RESOLUTION MEPC.52(32) adopted on 6 March 1992

AMENDMENTS TO THE ANNEX OF THE PROTOCOL OF 1978 RELATING TO THE INTERNATIONAL CONVENTION FOR THE PREVENTION OF POLLUTION FROM SHIPS, 1973

(New regulations 13F and 13G and related amendments to Annex I of MARPOL 73/78)

Figure 1

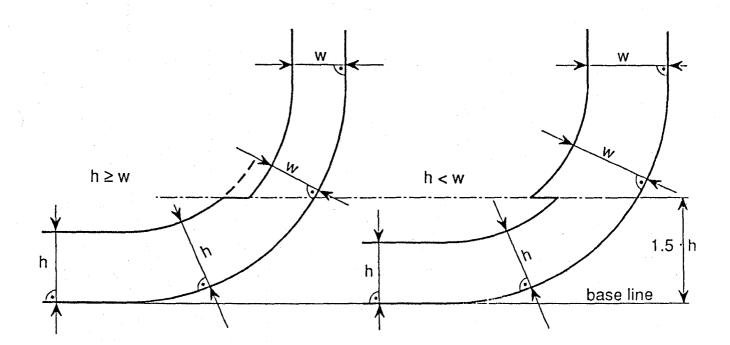
Wing tanks or spaces shall extend either for the full depth of the ship's side or from the top of the double bottom to the uppermost deck, disregarding a rounded gunwale where fitted. They shall be arranged such that the cargo tanks are located inboard of the moulded line of the side shell plating, nowhere less than the distance w which, as shown in figure 1, is measured at any cross-section at right angles to the side shell, as specified below:

At any cross-section the depth of each double bottom tank or space shall be such that the distance h between the bottom of the cargo tanks and the moulded line of the bottom shell plating measured at right angles to the bottom shell plating as shown in figure 1 is not less than specified below:

When the distances h and w are different, the distance w shall have preference at levels exceeding 1.5 h above the baseline as shown in figure 1.

$$w = 0.5 + \frac{DW}{20,000}$$
 (m) or

w = 2.0 m, whichever is the lesser.

The minimum value of w = 1.0 m.

$$h = B/15$$
 (m) or

h = 2.0 m, whichever is the lesser.

The minimum value of h = 1.0 m.

Figure 3

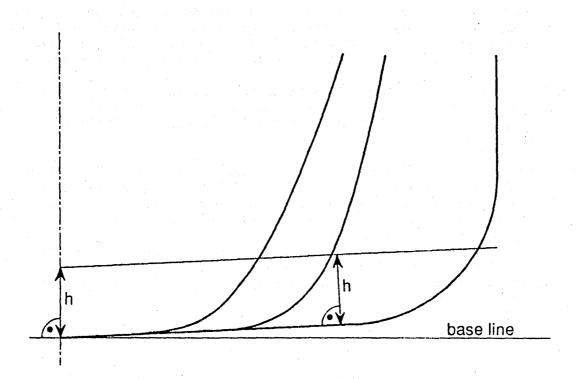
in the turn of the bilge area and at locations without a clearly defined turn of the bilge, the cargo tank boundary line shall run parallel to the line of the mid-ship flat bottom as shown in figure 3; and

h = B/15 (m) with a minimum value of h = 0.76 m;
